# Access Compliance Report Public Rights-of-Way (Curb Ramps)

Main Street: VANDERLIP\_AVE Cross Street: CAMERON\_LN Location: NW

ADA ID: RPAT211006102707 Ramp Type: Type 1 - Perpendicular Diagonal Initial Pass/Fail: Fail Overall Compliance: No Severity Score: 2

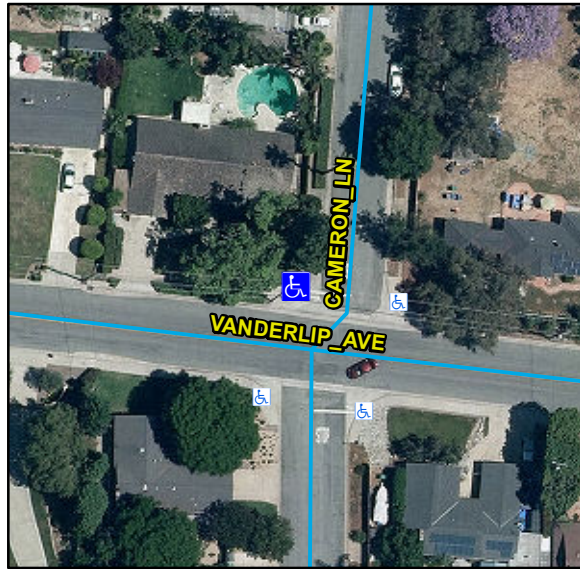
| Compliance | Description                           | Data | Compliance | Description                   | Data |
|------------|---------------------------------------|------|------------|-------------------------------|------|
| No         | Ramp Cross Slope (%)                  | 3.1  | N/A        | Flare Traversable LT          | N/A  |

Remove & Replace Curb Ramp With Two New Directional Ramps or Equivalent.

R304.5.3, STD 1115
